Avolites LTD Engineering Change Notice

ECN title	220R resistor mod for BGE encoders		
ECN Number	ECN-0215		
Related Product(s)	Titan Mobiles with BGE encoders SN from TM-5672		$\Delta V \Delta$
Date / Author	22/09/2022	GK	
Reasons for ECN	BGE encoder counting too fast		
Parts required	8200-0215 Titan Mobile ECN 215		
Tools required	T20 driver and hot glue gun		
Estimated time	10 minutes

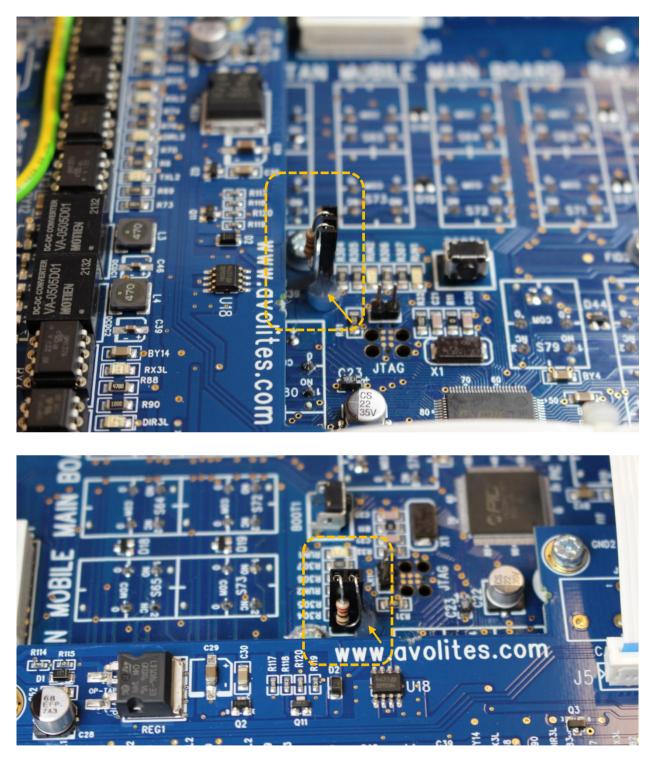
Fit the supplied 220R resistor onto **BOOT2** header on MMB board then secure it with hot glue (arrow)

Update the firmware to: Aug 26 2022
